SERVICE BULLETIN

Service Bulletin No.: DA20-32-02 Rev 0

Title: Nose Gear Fork, Fatigue

Figure 1

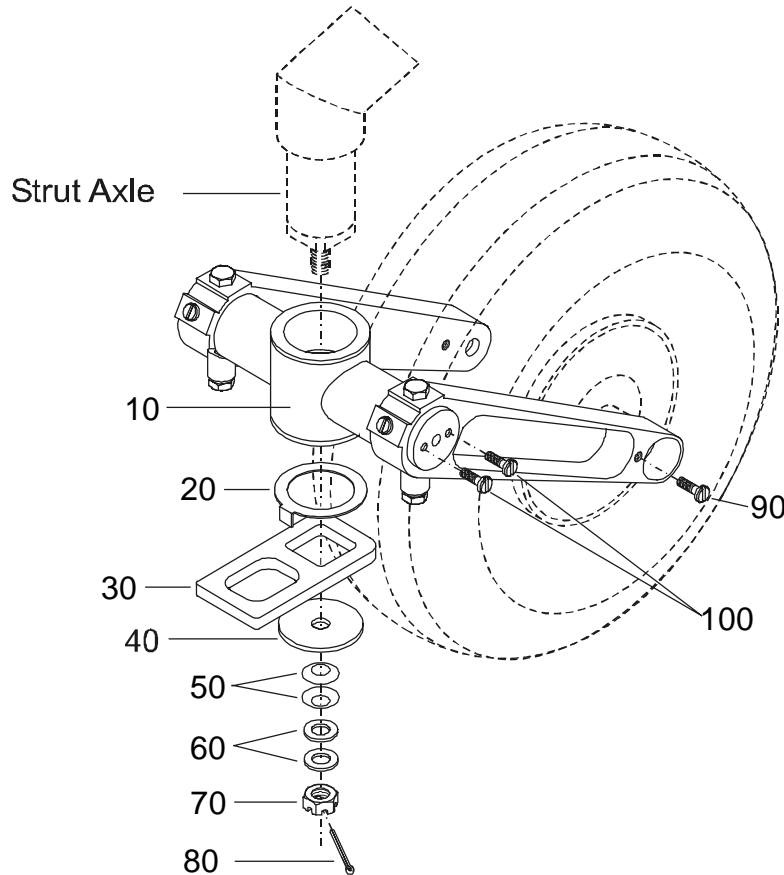
Note: Diamond Aircraft recommends an upgrade of the Steering Stop Plate to P/N 20-3220-00-23 (ITEM 30 in Figure 1) in place of P/N 20-3220-00-18 (see Figure 3) installed on some aircraft, before accomplishment of Part 2 of this service bulletin.
4. **Compliance:**

- 10.2.8** Install new fork assembly – refer to Figure 1 for assembly order.
- 10.2.9** Tighten pivot nut until a Breakout Force of 30 – 50 N (6.75 – 11.25 lbs.) is achieved in both directions along the axis of the axle (Figure 4).

Figure 3

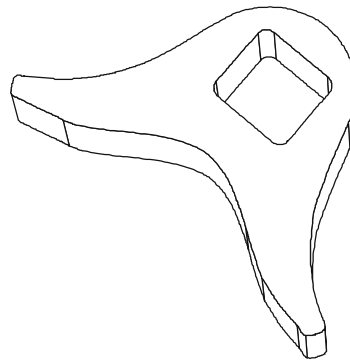
P/N 20-3220-00-18
Steering Stop Plate
Fitted to some aircraft.
